SDG&E Response To Ed Clark's Claims January 11, 2008

DOWN GUY CONSTRUCTION

Mr. Clark's Presentation Slide #2

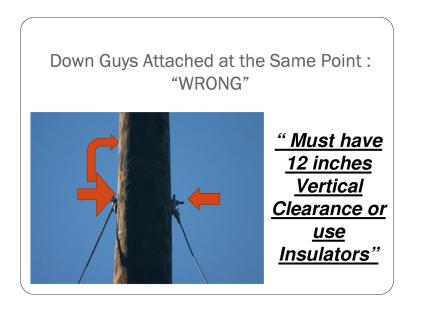
1. Attached at same location on pole "WRONG"

2. Insulators not utilized! _{#2} "WRONG"

SDG&E Response #2

Attachment of two separate anchor guys to the pole at the same point is allowed by California state code GO 95. Separation of 1 ft. is required if more than one guy is attached to the same anchor (GO 95 Rule 56.4-D-3 - b). As shown in Mr. Clark's presentation (see above), only one guy wire comes down to single anchor on each side of the pole.

The 1 ft. separation of attachment point on the pole is not required, if only one guy wire is attached to the anchor guy.
